# UNITED STATES PATENT AND TRADEMARK OFFICE

APPLICATION NO.	FILING DATE	FIRST NAMED INVENTOR	ATTORNEY DOCKET NO.	CONFIRMATION NO.
10/790,259	03/01/2004	Tomoyuki Fujii	815_012	9799
25191	7590	07/13/2006	EXAMINER	
BURR & BROWN PO BOX 7068 SYRACUSE, NY 13261-7068			BAUER, SCOTT ALLEN	
			ART UNIT	PAPER NUMBER
			2836

**Office Action Summary**

FIG. 4A

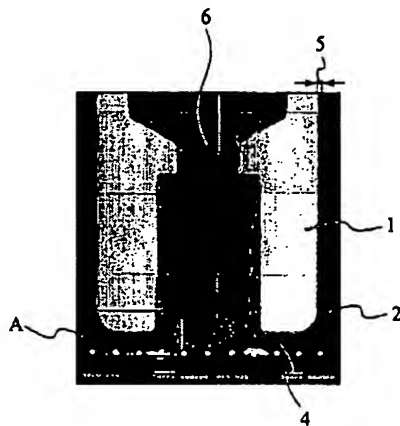
1. The drawings are objected to because the pictures submitted as Figs. 4A, 4B, 5A & 5B are not of sufficient quality to enable the invention. Corrected drawing sheets in compliance with 37 CFR 1.121(d) are required in reply to the Office action to avoid abandonment of the application. Any amended replacement drawing sheet should include all of the figures appearing on the immediate prior version of the sheet, even if only one figure is being amended. The figure or figure number of an amended drawing should not be labeled as "amended." If a drawing figure is to be canceled, the appropriate figure must be removed from the replacement sheet, and where necessary, the remaining figures must be renumbered and appropriate changes made to the brief description of the several views of the drawings for consistency. Additional replacement sheets may be necessary to show the renumbering of the remaining figures. Each drawing sheet submitted after the filing date of an application must be labeled in the top margin as either "Replacement Sheet" or "New Sheet" pursuant to 37 CFR 1.121(d). If the changes are not accepted by the examiner, the applicant will be notified and informed of any required corrective action in the next Office action. The objection to the drawings will not be held in abeyance.
